Landmark Trees

Your ref: 2021/1358/P

Our ref: SHH\_28AVE\_AIA\_Ltrr\_01

**Re: Planning Application Ref: 2021/1358/P**  
**Objections regarding the Proposed Development at No.28 Avenue Road, London**  
**NW8 6BU**

Enc. App 1: Amended Tree Constraints & Impact Assessment Plans 02/09/21

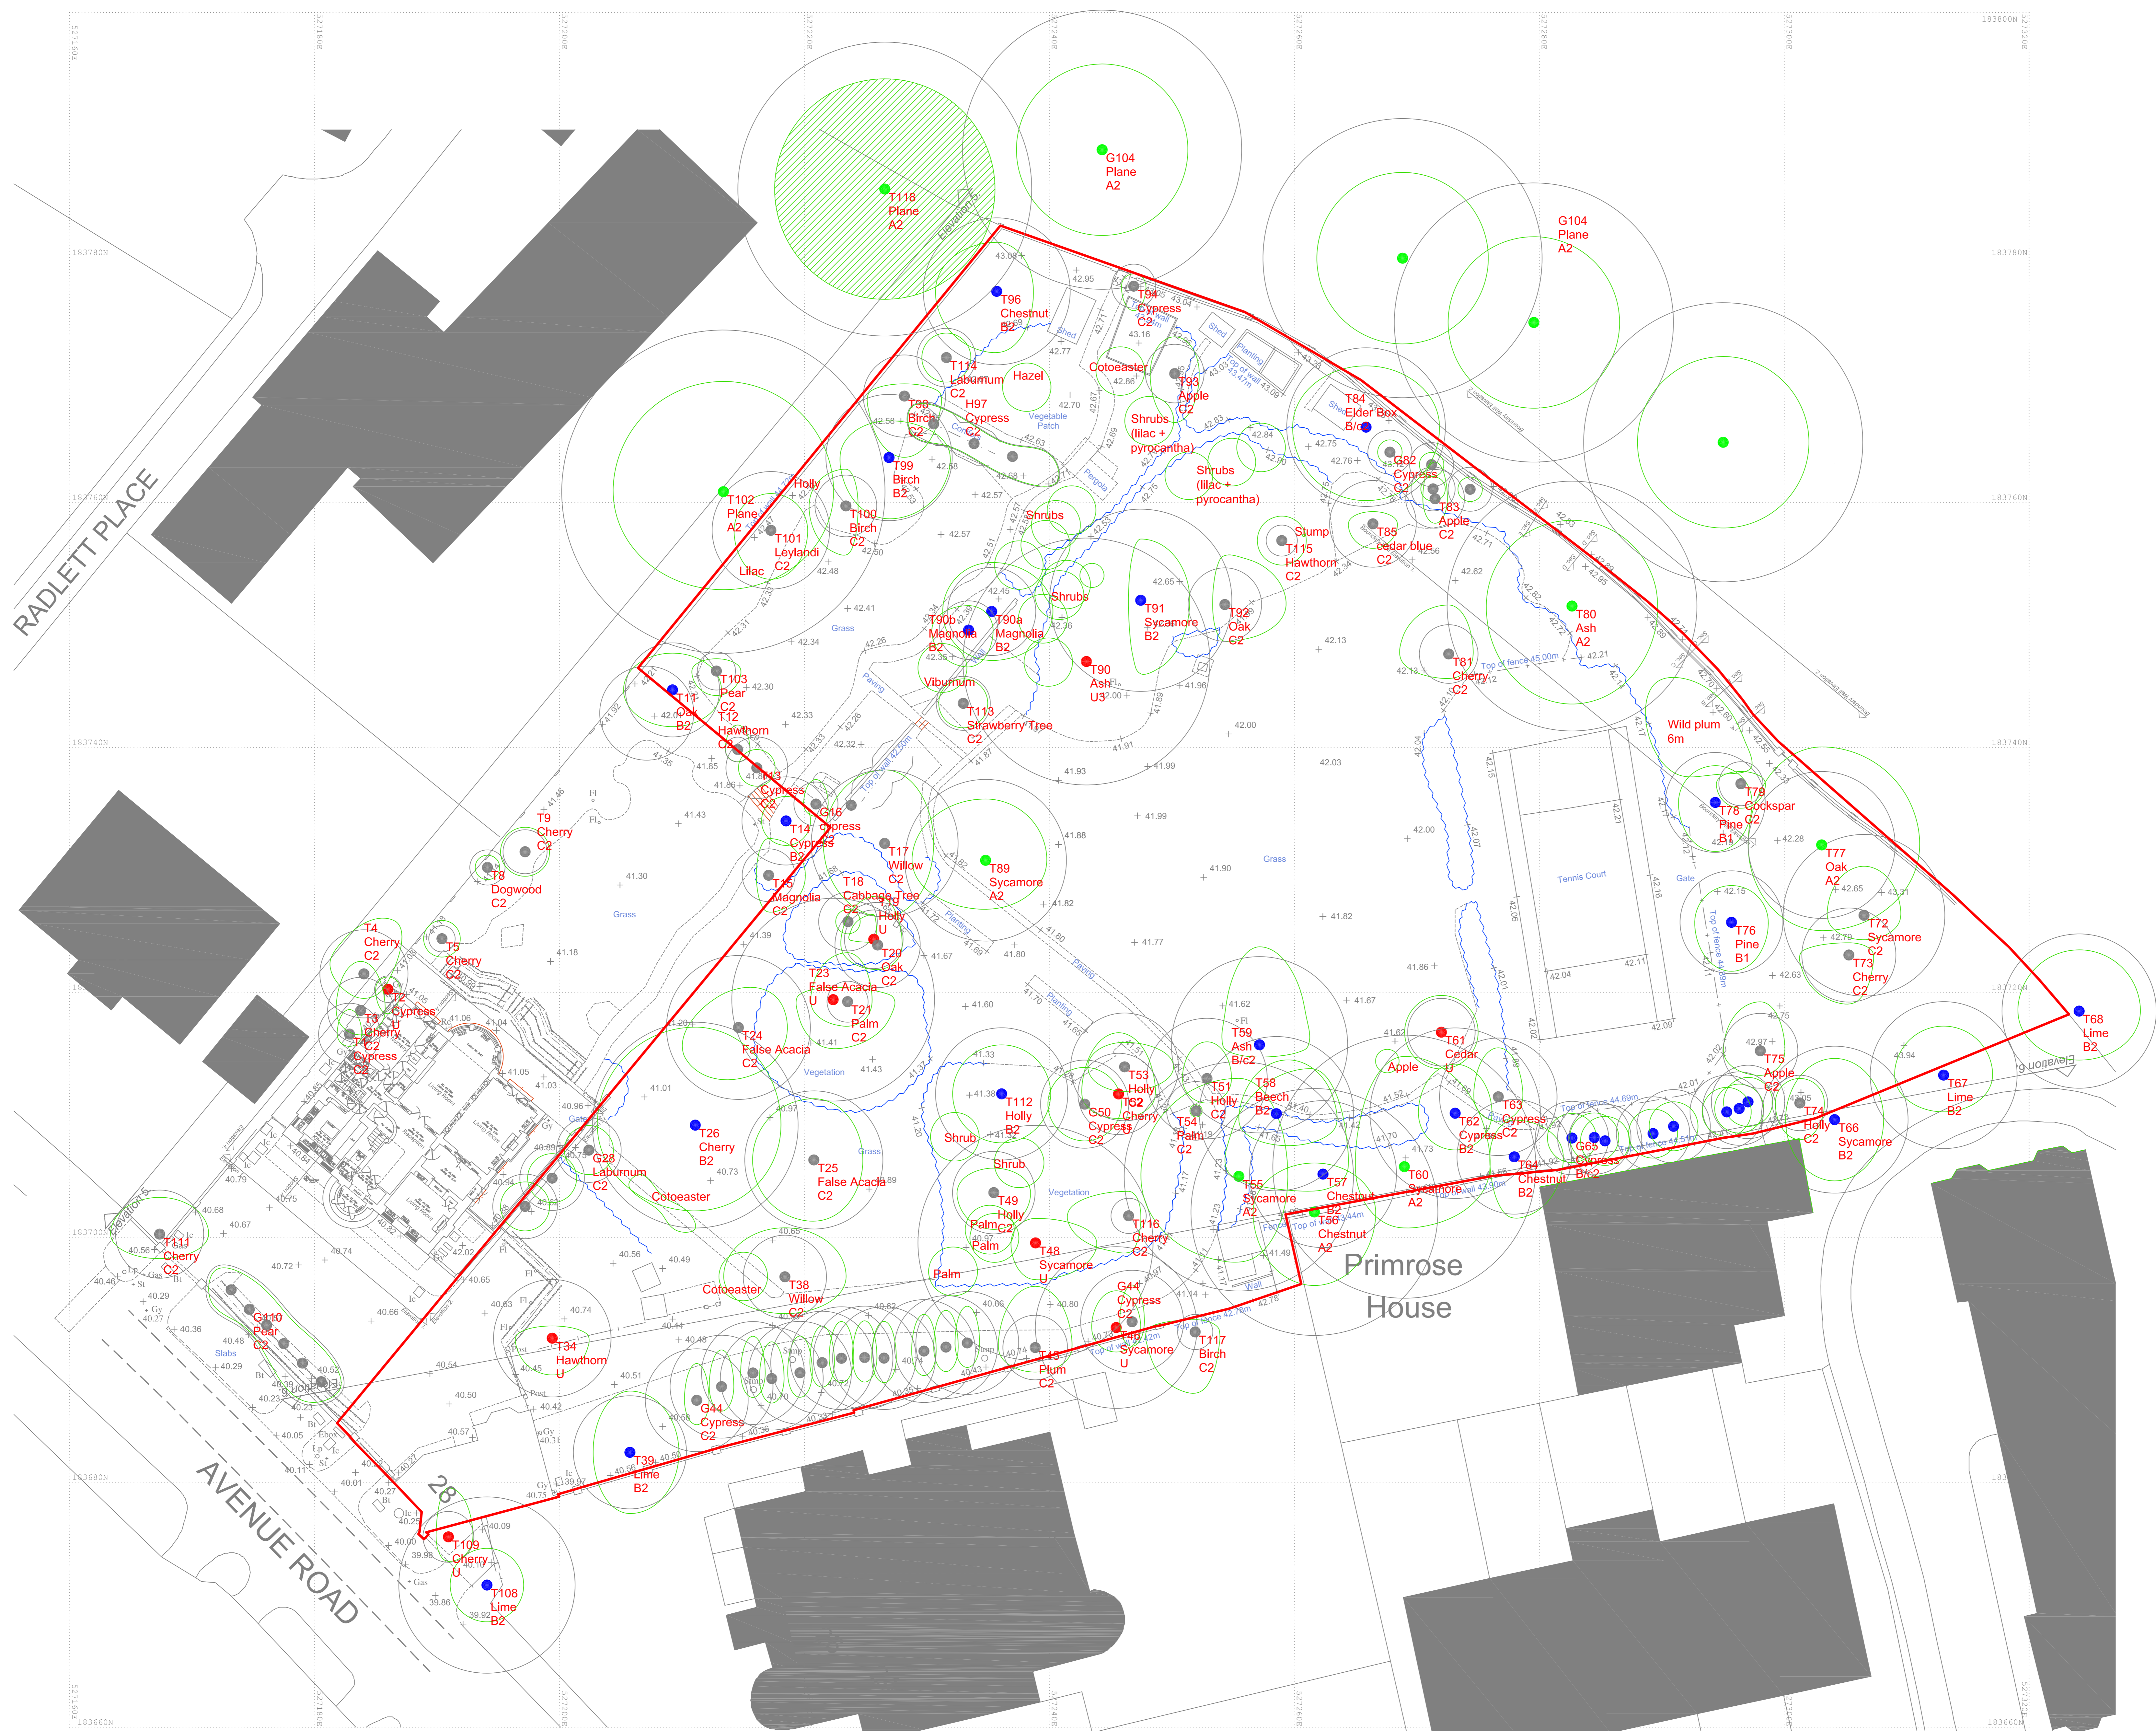
ii) The key omission of the survey appears to concern that of a second, off-site plane tree within Radlett Place. From my perspective, this was not an omission but another judgment call. I chose to include the nearer plane tree but not the more remote one of the pair, considering it smaller and removed from any proposals, on the other side of a substantial wall with pro rata foundations (likely inhibiting root colonisation of the application site). Its influence is further obstructed / tempered by the presence of a mature horse chestnut (T96) on the opposite side of the boundary within the application site. Consultants get an eye for these things after years of surveying. To accommodate the objection, we have added in the additional tree to our plan, using the given locations and dimensions on the survey plan, 700(002) Rev PL02, supplied in the review. We have plotted the Root Protection Area as a simple initial circle; the reviewer may wish to modify this into a polygon based on their greater knowledge of the neighbouring site and its structures (wall and building foundations etc.). In general, though, if a conventional circular RPA is unaffected by proposals, it is unlikely that such modification will lead to a dramatic rise in impact. In this case, neither the conventional RPA nor canopy significantly overlap the application site and the tree's inclusion is essentially academic / to provide peace of mind. Please see the amended survey plan at Appendix 1 to this letter.

To conclude, our report provides a compliant accompaniment to planning with a robust assessment of impacts and their mitigation. There are no substantive omissions in that assessment beyond the de minimus, with the plane tree at 1 Radlett Place serving as a primary example: I have included it on plan at Appendix 1 to oblige the reviewer but without material consequence. I have demonstrated where other moot omissions have been duly considered within the structure of the report and how that complies with the guidance in the relevant British Standard. The principal disagreement appears to lie in just how much detail should be specified or reserved before planning. My view is that a line must be drawn somewhere, and common sense should be our guide.
